# Access Compliance Report Public Rights-of-Way (Curb Ramps)

Main Street: NEARING\_DR Cross Street: BUCHANAN\_DR Location: NE

ADA ID: RPRK210928172258 Ramp Type: Type 1 - Perpendicular Diagonal Initial Pass/Fail: Fail Overall Compliance: No Severity Score: 16

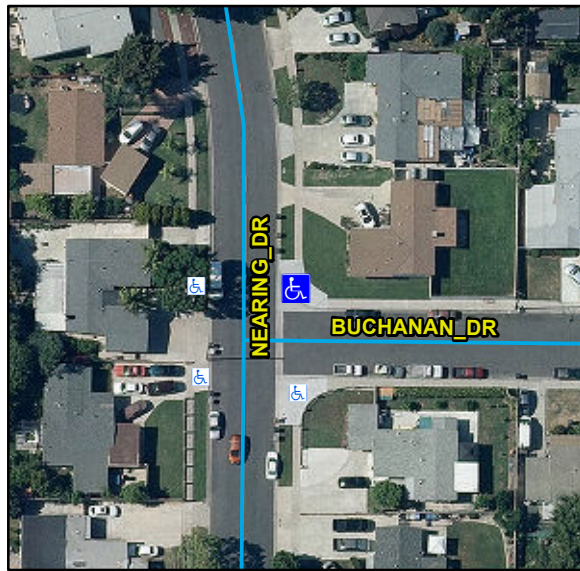
| Compliance | Description                           | Data | Compliance | Description                   | Data |
|------------|---------------------------------------|------|------------|-------------------------------|------|
| No         | Ramp Run Slope (%)                    | 10.5 | N/A        | Flare Slope LT (%)            | N/A  |
| No         | Ramp Cross Slope (%)                  | 3.5  | N/A        | Flare Traversable LT          | N/A  |

Remove & Replace Curb Ramp With Two New Directional Ramps or Equivalent.

R304.2.2, R304.5.3, STD 1115
